Re: Residences at Acorn Park  
Site Plan, Building and Roadway Modifications  
Acorn Park Drive  
Belmont, Massachusetts

At the request of O'Neill Properties, Vanasse & Associates, Inc. (VAI) has evaluated the impact of shifting the buildings and roadways on the site plan and consequent modifications to Acorn Park Drive to avoid a resource area in the rear of the property. It is our understanding the spatial relationships between all site plan elements does not change and the total site plan has been relocated towards the northeast.

Fire Truck (Ladder) Access Plan

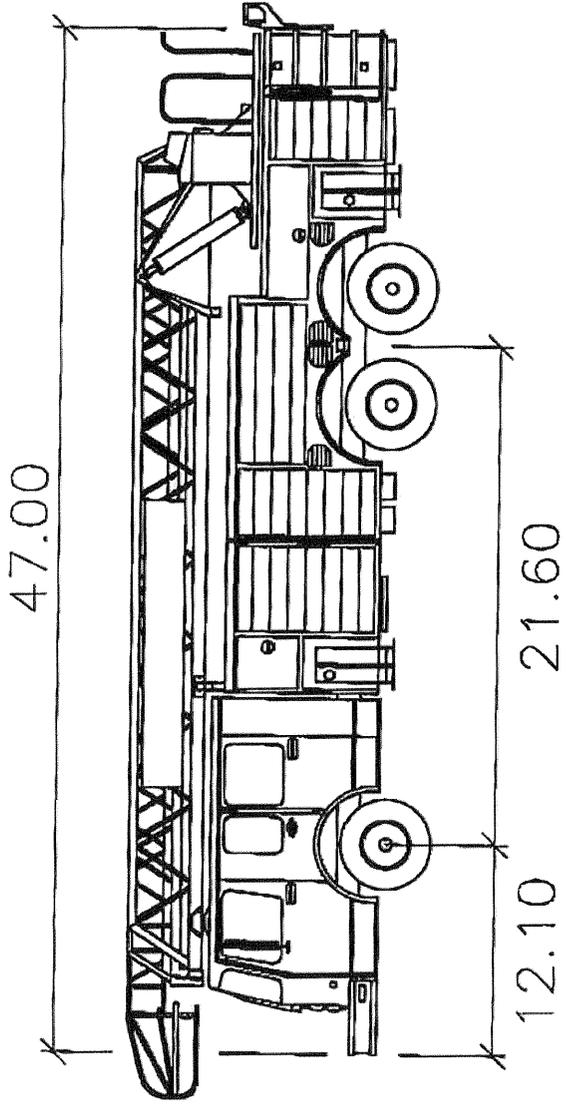
**Life-Safety Issues** – AutoTurn© runs of a single-unit unarticulated Fire Vehicle indicated, as before, full access to all sides of the building is possible. Driveway widths, corner radii and transitional areas did not change with the building relocation and remain in conformance with acceptable and required standards.
